Related to comments # i-42 and # i-65

IEEE P802.3ct Task Force, Teleconference, 16 November 2020

Introduction

Proposal for revised Table 154-10, black link

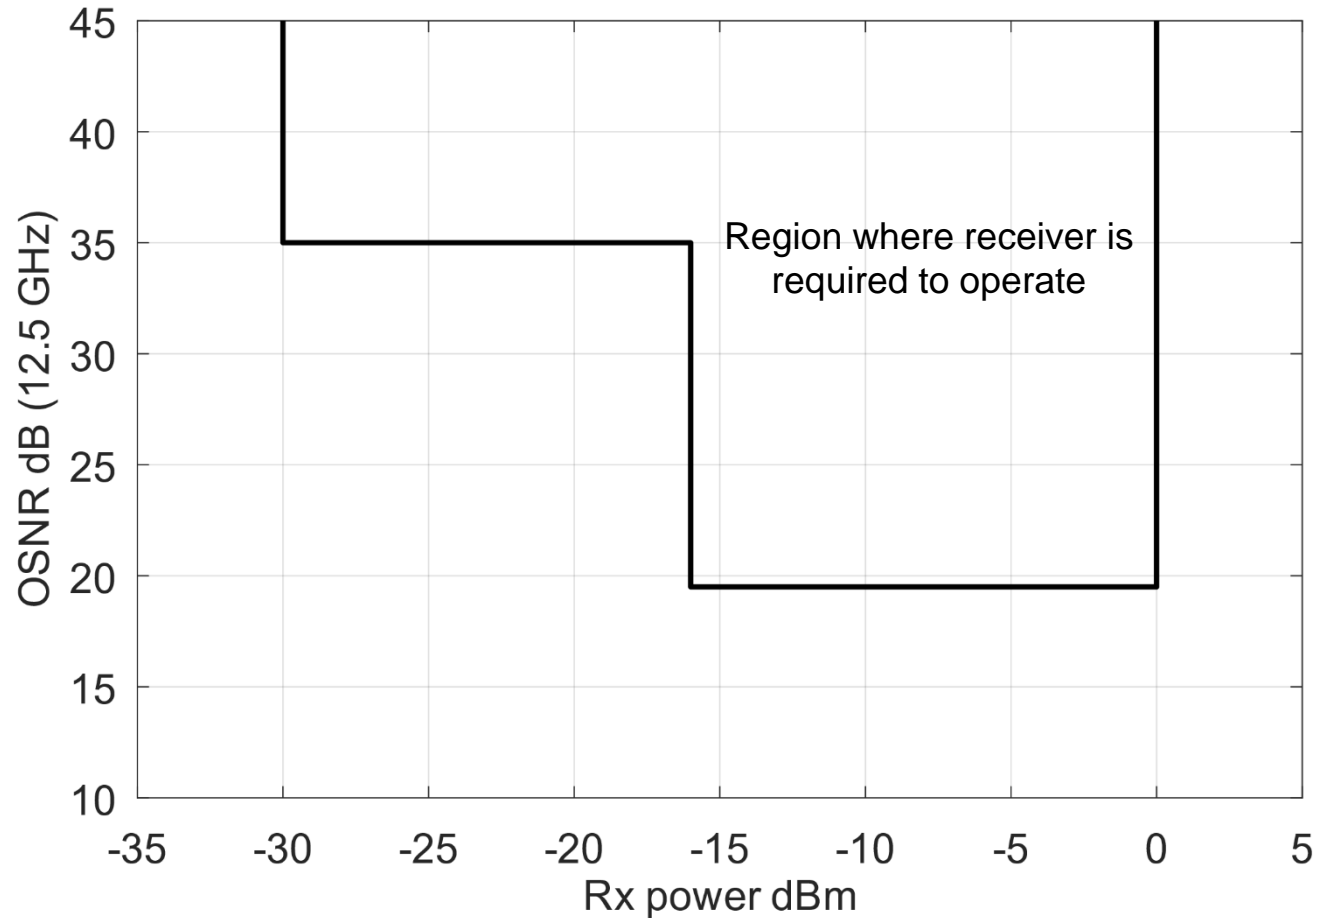
Amplified versus unamplified black links

- The current version of Clause 154 has been written for black links that may contain optical amplifiers, while also allowing operation over unamplified black links.
- Concerns have been raised, and comments submitted, that the current optical specifications could imply two PMDs instead of one.
- The draft will need to be modified in such a way that it is clear that it is one PMD only.
- In that way both amplified and unamplified applications can be supported as requested in the CSD.

- The following slides contain (hopefully) complete proposals for modification of Clause 154:
 - Removing “amplified” and “unamplified” from parameter names.
 - Removing 193.6 from OSNR related parameter names.
 - Introduction of coupling of OSNR and link output/Rx input power levels.
 - Introduction of “Optical path penalty” for $\text{OSNR} \geq 35$ dB
 - Introduction of new Figure from slide 10 of https://www.ieee802.org/3/ct/public/19_07/stassar_3ct_02_0719.pdf, without the labelling of “amplified” and “unamplified”.

Description	Value	Unit
Channel spacing (min)	GHz	100
Ripple (max)	2.5	dB
<u>Average output power at TP3 (max)</u>	<u>0</u>	<u>dBm</u>
<u>Average output power at TP3 (min):</u> <u>for OSNR at TP3 < 35 dB (12.5 GHz)</u> <u>for OSNR at TP3 ≥ 35 dB (12.5 GHz)</u>	<u>-16</u> <u>-29</u>	<u>dBm</u> <u>dBm</u>
<u>OSNR at TP3 (min)</u>	<u>19.5</u>	<u>dB (12.5 GHz)</u>
<u>Optical path OSNR penalty (max),</u> <u>for OSNR at TP3 < 35 dB (12.5 GHz)</u>	3	dB
<u>Optical path penalty (max),</u> <u>for OSNR at TP3 ≥ 35 dB (12.5 GHz)</u>	<u>1</u>	<u>dB</u>
Chromatic dispersion (max)	2000	ps/nm
Chromatic dispersion (min)	0	ps/nm
Fiber chromatic dispersion slope at channel center frequencies ^a (min)	0.05	ps/nm ² km
Optical return loss at TP2 (min)	25	dB
Differential group delay, DGD ^b (max)	20	ps
Polarization dependent loss (max)	1.5	dB
Polarization rotation speed (max)	50	krad/s
Inter-channel crosstalk at TP3 (max)	-16	dB

<u>Average output power at TP3 (max)</u>	<u>0</u>	<u>dBm</u>
<u>Average output power at TP3 (min):</u> <u>for OSNR at TP3 < 35 dB (12.5 GHz)</u> <u>for OSNR at TP3 ≥ 35 dB (12.5 GHz)</u>	<u>-16</u> <u>-29</u>	<u>dBm</u> <u>dBm</u>
<u>OSNR at TP3 (min)</u>	<u>19.5</u>	<u>dB (12.5 GHz)</u>
<u>Optical path OSNR penalty (max),</u> <u>for OSNR at TP3 < 35 dB (12.5 GHz)</u>	<u>3</u>	<u>dB</u>
<u>Optical path penalty (max),</u> <u>for OSNR at TP3 ≥ 35 dB (12.5 GHz)</u>	<u>1</u>	<u>dB</u>
